***Review of  
Erosion and Sedimentation Program  
Delegation to the North Carolina Department  
of Transportation, Division of Highways***

***November 29, 2011***

***NCDENR  
North Carolina Department of Environment  
and Natural Resources  
Division of Land Resources  
Land Quality Section***

*Lebanon Road  
bridge site*

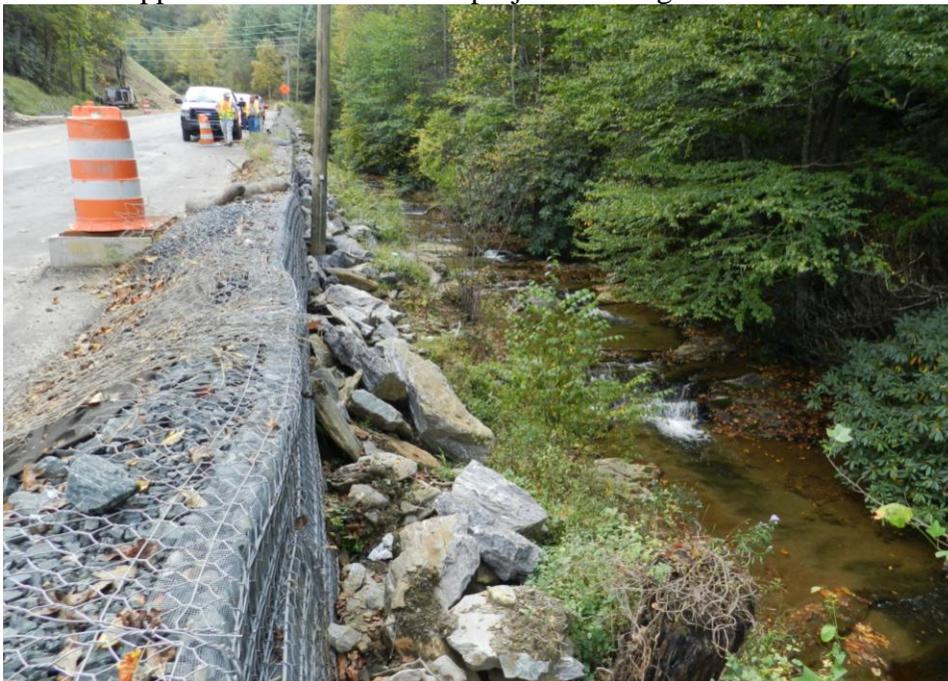
Lebanon Road— This project included replacing a bridge on a two lane road. One side of the road widening had been done and permanently stabilized. The other side was under construction. No stream sedimentation was observed. The project was in good condition.
